NEW FEATURES

■ EXTERIOR

▶ Standard Body Models ◀

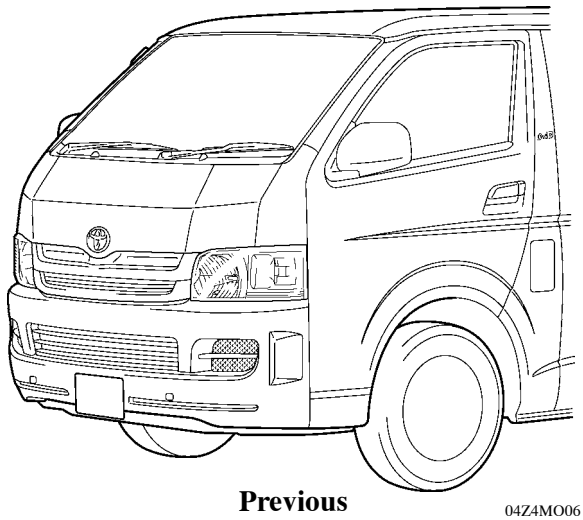
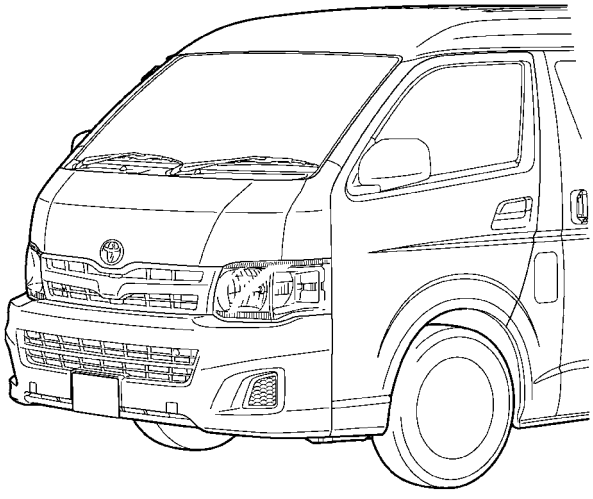
- The designs of the radiator grille, front bumper, and headlights have been changed, resulting in a brand new appearance.
- Large sized headlights with lenses which appear transparent have been adopted for all models to create an expensive look.
- A new radiator grille is available as standard equipment for all models except the automatic transmission models for Thailand and the Philippines package automatic transmission models. A design whereby the new radiator grilles are integrated with the headlights has been adopted, and they have been provided in accordance with the grade and destination, as with the previous models, and as shown in the table below.

- Highly-recyclable, lightweight TSOP (Toyota Super Olefin Polymer) has been used for the front bumpers of all models to reduce the vehicle weight. In addition, a design whereby the front bumpers of the wide body models protrude in the front has been adopted to realize a dynamic feeling and a sensation of extra width. For the front bumpers of both the standard and wide body models, the original material color is used for the DX grade models (excluding the Commuter models for Thailand), and the same color as that used for the external panel has been used for the GL grade models and the DX grade Commuter models for Thailand.
- The designs of the fog light covers (fog lights not installed) and the fog light bezels (fog lights installed) of all models have been changed to realize a feeling of novelty. The design of the fog lights has not changed.

04Z4MO07Y

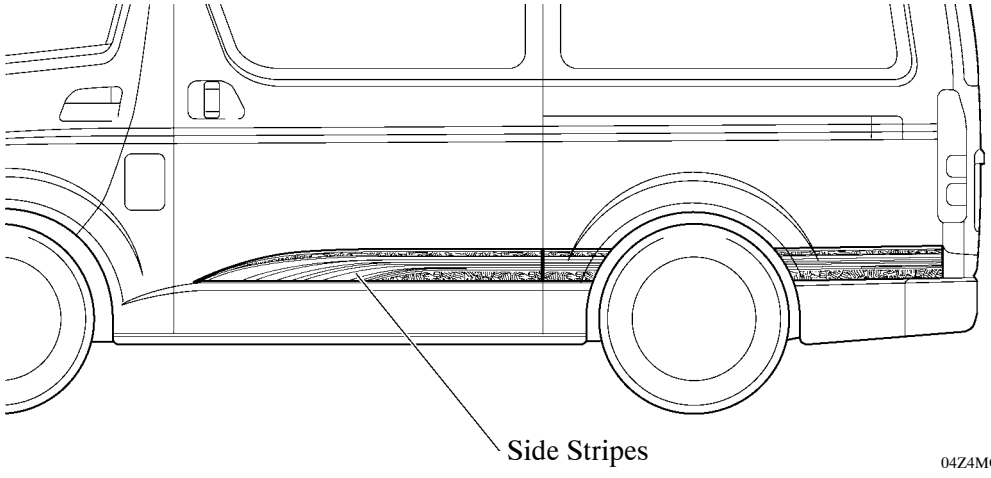
- The design of the side stripes (available as an option for all models except for the automatic transmission models for Thailand) has been changed.
